**Subject: Response to Alameda County Environmental Health Public Comments for Fuel Leak Case No. RO0000207 and GeoTracker Global ID T0600102092, Mission Valley Rock and Asphalt, 7999 Athenour Way, Sunol, CA 94586**

Subject:  
Response to Alameda County Environmental Health Public Comments for Fuel Leak  
Case No. RO0000207 and GeoTracker Global ID T0600102092, Mission Valley  
Rock and Asphalt, 7999 Athenour Way, Sunol, CA 94586

Date:  
June 1, 2012

SITE PLAN

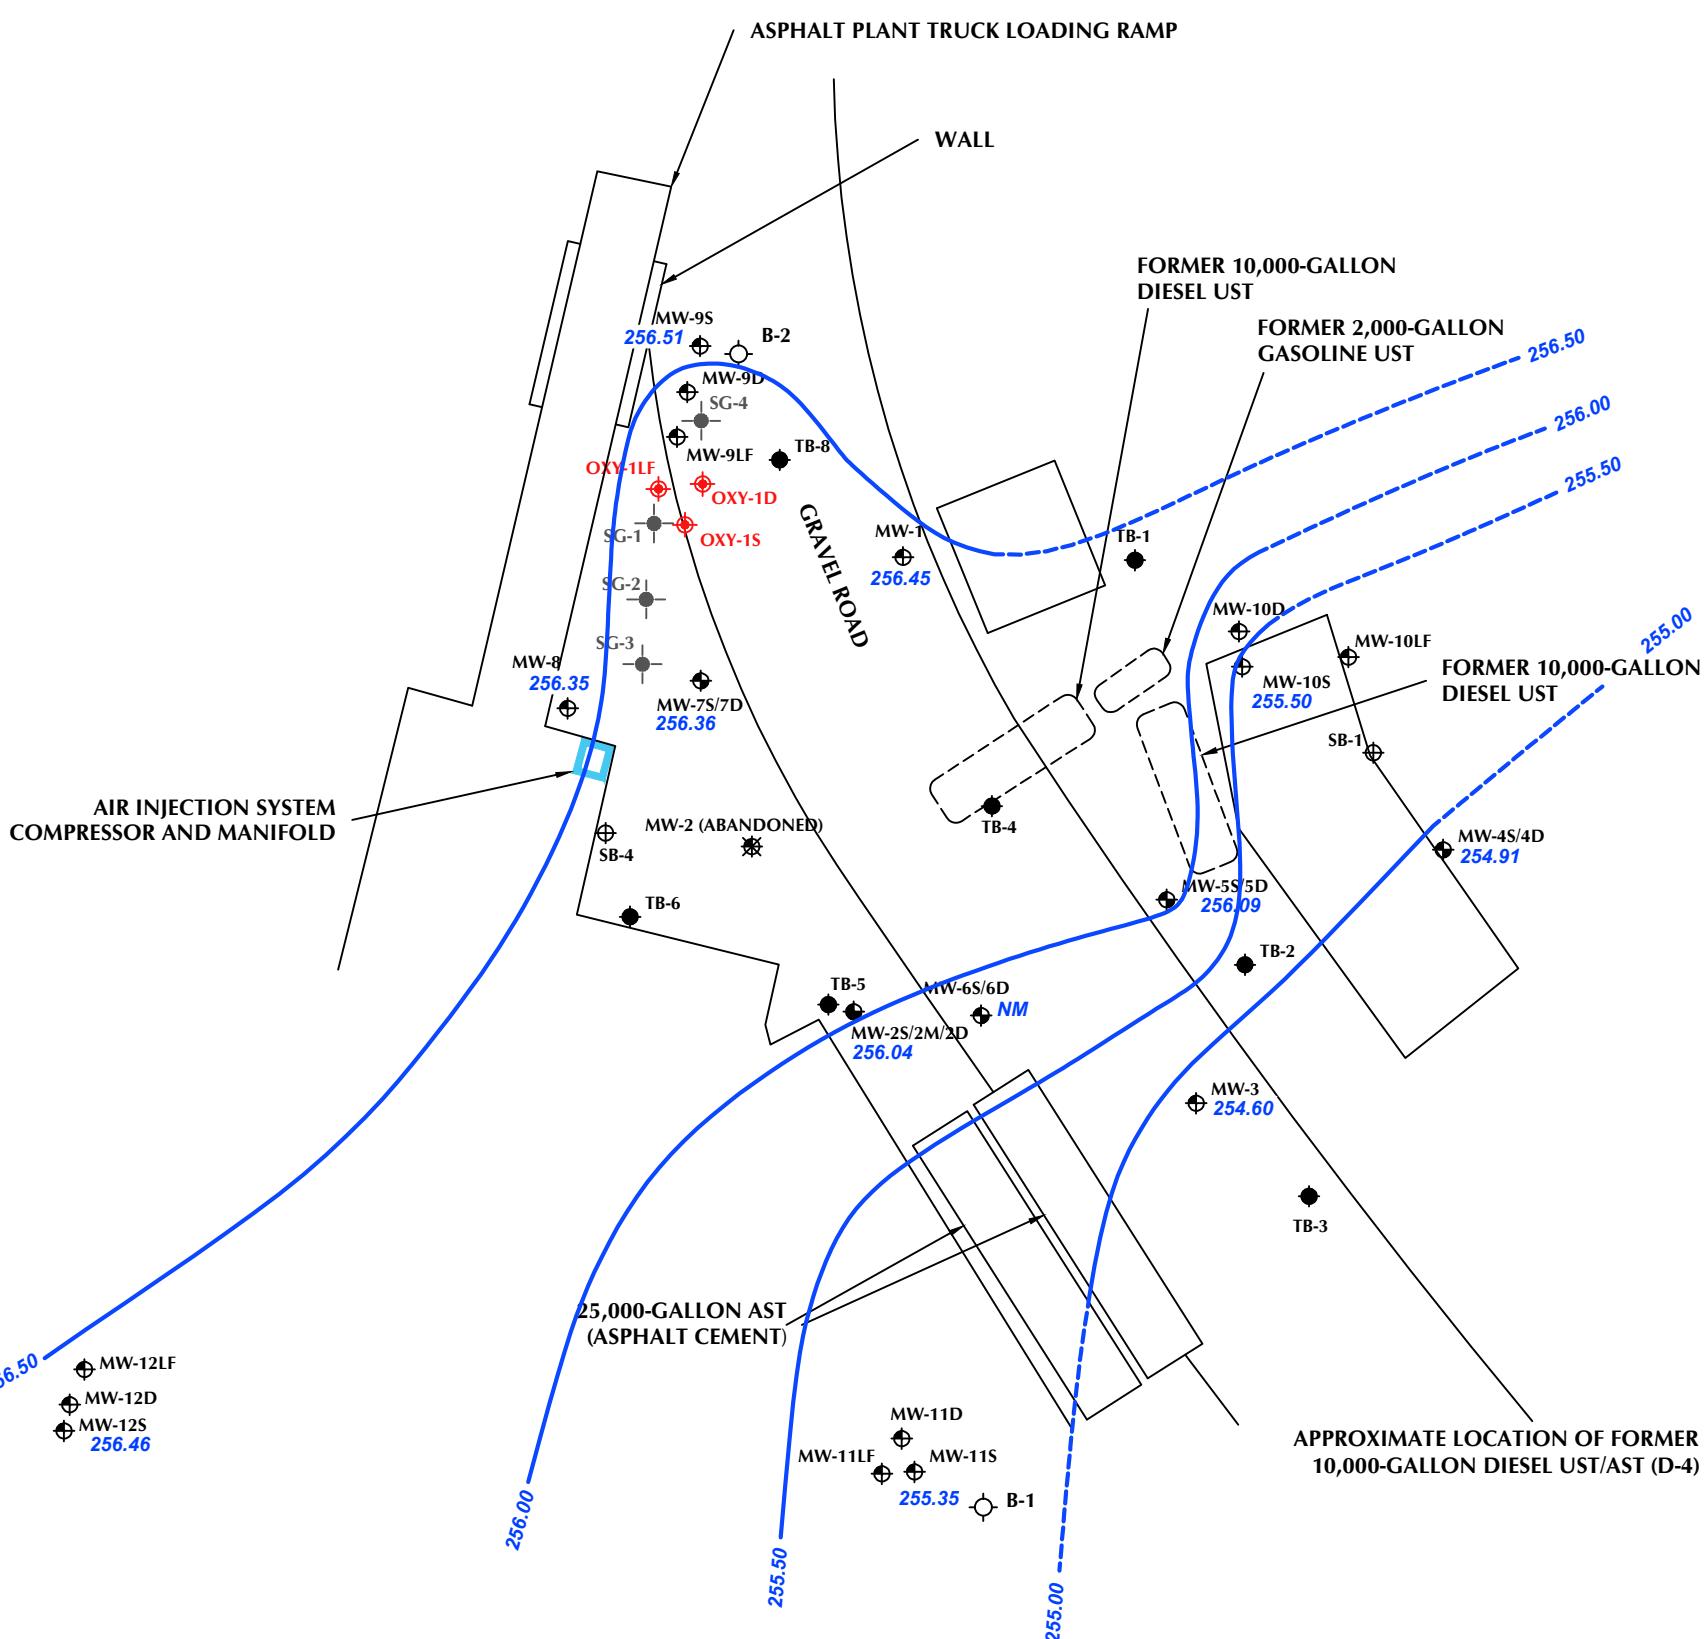
**1. Confirming No Changes in Water Level Elevations and Hydraulic Gradient.** In order to confirm that dewatering efforts in the region have not impacted the plume at the Hanson site, we request that you measure the water levels in each existing monitoring well at the site. Please present these data in tabular form along with groundwater elevation contour maps for each vertical zone. These results are to be compared to historic water level and hydraulic gradient data in a brief letter report.

In response to this comment, depth to groundwater was measured in the 26 groundwater monitoring wells on May 1, 2012 (Figure 2). Depth to groundwater was not monitored in the three injection wells.
